8th ST., GROVE, HYDE, MARKET

SRC 2018-058
2/25/18

NEW PHASE NUMBERS - ET 2015-418

SRC 2018-058

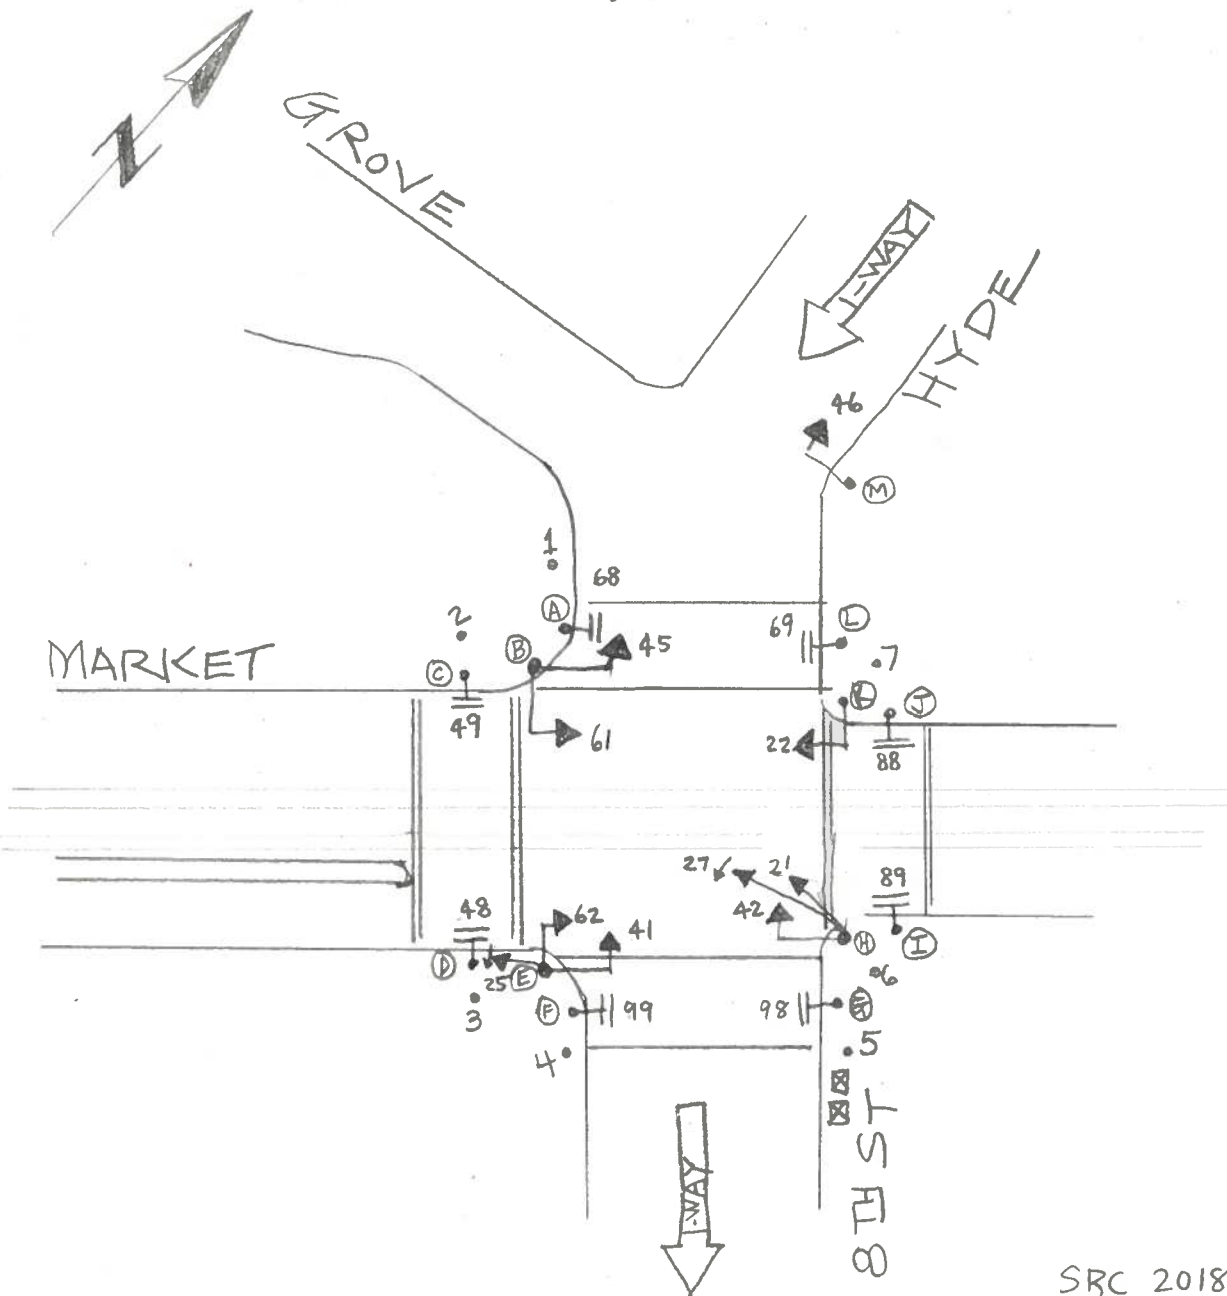
Changed Phase Numbers (2016):

$\Phi 0 \rightarrow \Phi 6$

$\Phi 1 \rightarrow \Phi 2$

$\Phi 2 \rightarrow \Phi 4$

$\Phi 3P \rightarrow \Phi 8P$

Changed Phase Numbers (2018):

$\Phi 2P \rightarrow \Phi 9P$

SRC 2018-058: Upgrade signal 21 on pole (H) to 3S12" side-mounted signal w/ backplate.
